**Meeting of the Central Valley Flood Protection Board
August 24, 2012
Staff Report – Encroachment Permit
California Department of Transportation (Caltrans)
Minkler Bridge Removal and Replacement, Fresno County**

Consider approval of Permit No. 18761.

The applicant proposes to remove the SR180 (East Kings Canyon Road) bridge (No. 42-0074) over the Kings River Overflow channel and replace it with a wider, concrete slab bridge (No. 42-0437) along the existing roadway alignment and profile.

Figure 2

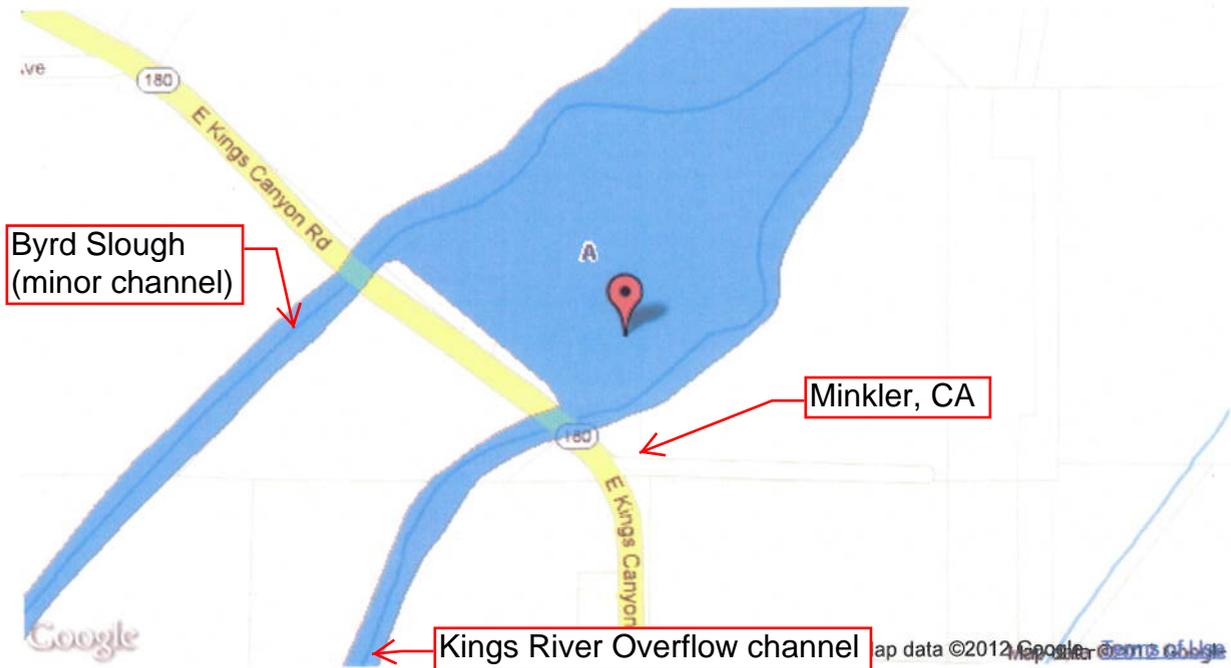
It should be noted the FEMA Flood Insurance Rate Map (FIRM) for this area indicates a common floodplain area between these two adjacent low-flow channels upstream of SR180, and two separate low-flow channels downstream of SR180 (See Attachment C, Figure 2).

Figure 3: HEC-RAS Schematic Diagram of Entire Hydraulic Model
 (Aerial Image Source: Caltrans DHIPP)

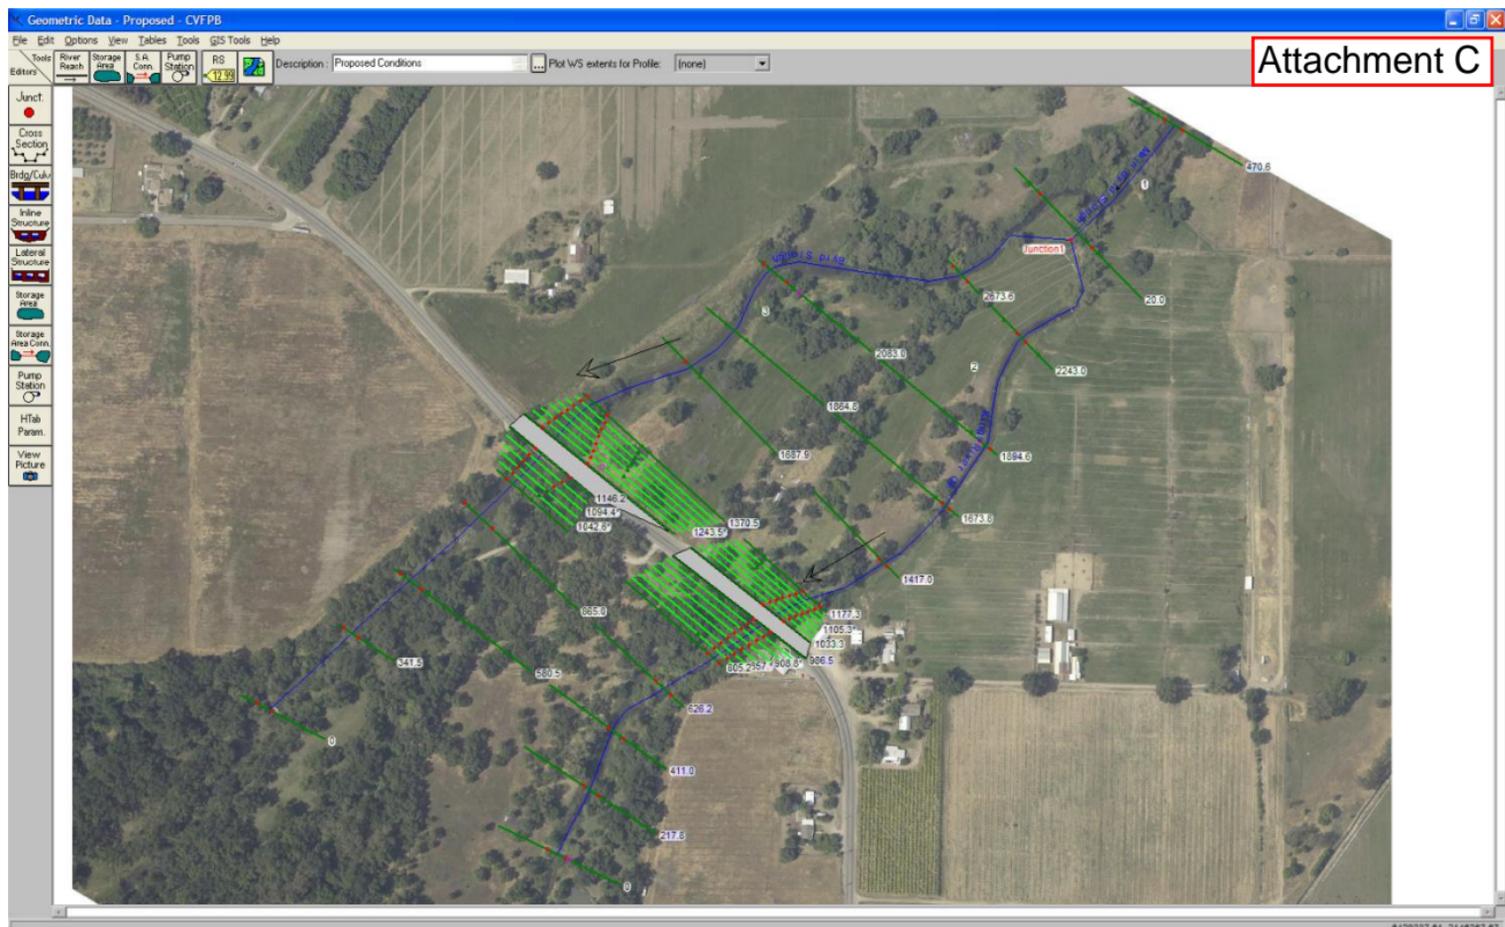
For the purposes of evaluating potential hydraulic impacts due directly from the proposed Minkler Bridge replacement project, the existing and proposed conditions were evaluated using HEC-RAS Version 4.1 hydraulic modeling software using the Board staff’s design discharge criteria. The hydraulic model was created using geometric data provided by field surveys, bridge/channel design details from As-Built and proposed Plan Sheets, and other necessary assumptions required to run the model. The survey data was referenced to NGVD29 vertical datum and consisted of representative cross sections taken across the channel and floodplain area, extending roughly 2,000 feet and 1,000 feet upstream and downstream of SR180, respectively (See Attachment C, Figure 3).

**FIGURE 4A - HEC-RAS Cross-Section of Existing Bridge
Looking downstream (D/S) direction at U/S face of Kings River Overflow, Br. No. 42-0074**

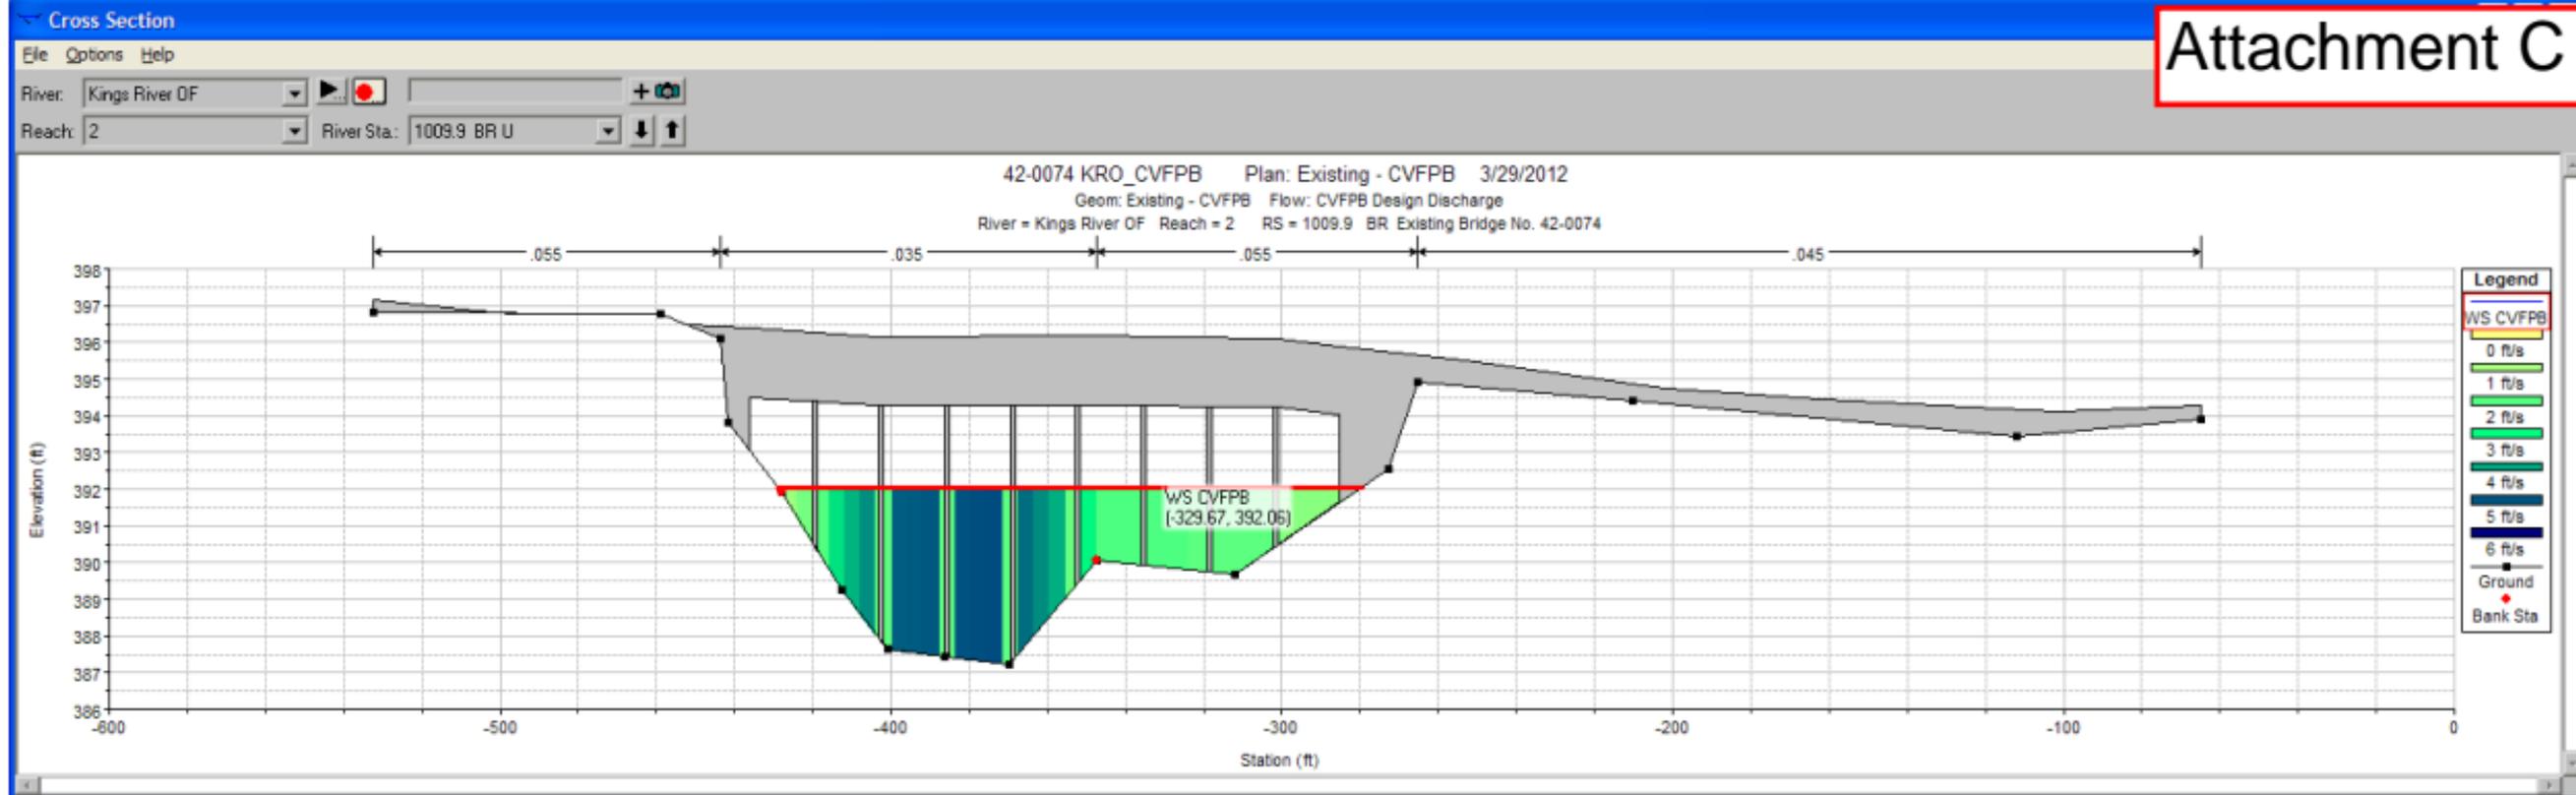
For WSEL comparisons, the computed water surface elevation at both the existing and proposed upstream bridge faces is 392.1 feet (rounded off to 0.1 feet). Based on these computed WSEL values, there is no anticipated change in WSEL due to construction of the proposed bridge replacement project (See Attachment C, Figures 4A and 4B).

**FIGURE 4B - HEC-RAS Cross-Section of Proposed Bridge
Looking D/S direction at U/S face of Kings River Overflow, Br. No. 42-0437**

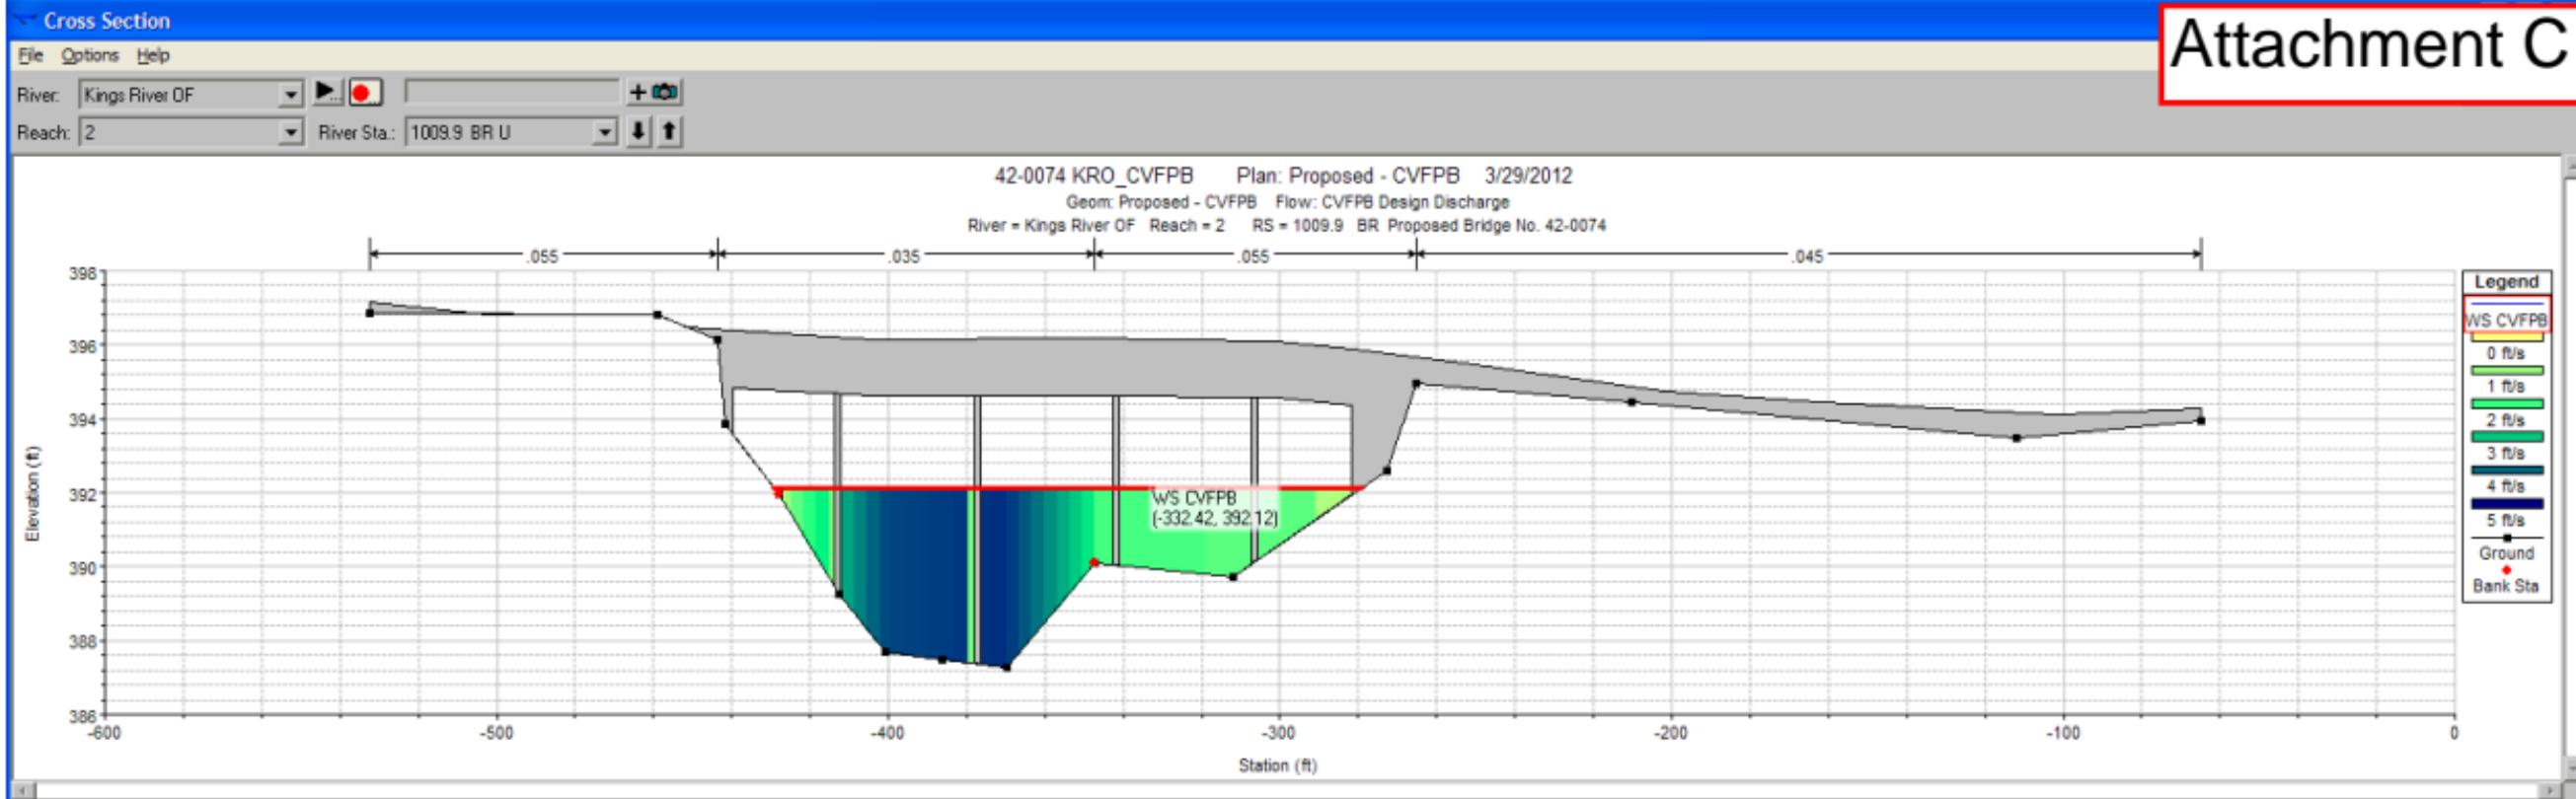
Minimum soffit elevations for the existing and proposed bridges are 393.8 feet and 394.2 feet respectively. Based on computed WSELs and minimum soffit elevations there is roughly 1.7 feet of freeboard [$393.8 - 392.06 = 1.74$, rounded to 1.7] for the existing bridge, and 2.1 feet of freeboard [$394.2 - 392.12 = 2.08$, rounded to 2.1] for the proposed bridge (See Attachment C, Figure 5). CCR 23 requires 2.0 feet of freeboard below the minimum soffit elevation for minor streams therefore the proposed bridge is compliant with CCR 23.

TWENTY-EIGHT: The soffit of the new bridge shall be a minimum of 2 feet above the flood plane

elevation of 392 feet, NGVD29.

Figure 6: HEC-RAS Hydraulic Design - Estimated Kings River Overflow Bridge Scour
 (Scour Calculation Method: Hydraulic Engineering Circular No. 18 (HEC-18) Manual, "Evaluating Scour at Bridges" (4th Edition, March 2001).)

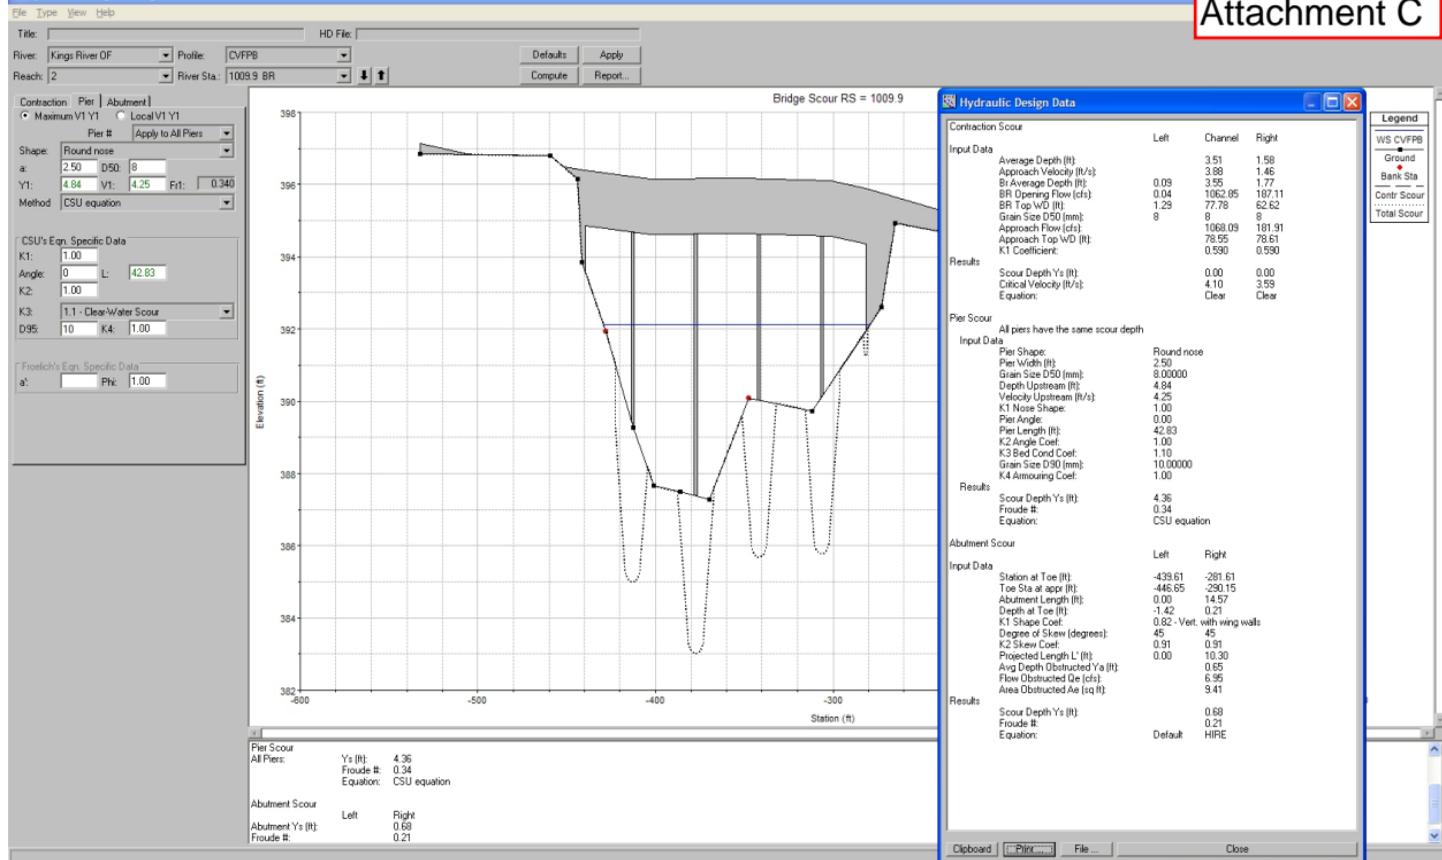
The HEC-RAS software also uses direct hydraulic results from the HEC-RAS model to provide scour estimates. Based on the proposed bridge details (pier walls) and current assumptions used for scour evaluation purposes, the calculated local pier scour depth was 4.0 feet. Based on the HEC-RAS model results for assumed maximum flow conditions, both proposed abutments appear to be generally located outside and above the local calculated maximum WSEL, and are not expected to be subject to significant local scour. Based on a current thalweg elevation of 387.0 feet, and considering a total channel degradation of one foot with local pier scour depth of four feet, a potential local channel bed elevation of 382.0 feet is assumed at any pier location (Piers 2 – 5). For either abutment face the potential local channel bed elevation of 386.0 feet is assumed, which considers the current thalweg elevation plus one foot of long-term channel degradation. In the event that future significant thalweg migration occurs towards the abutments, it should be a relatively gradual process that would likely allow adequate time to detect and address any concerns as required (See Attachment C, Figure 6).
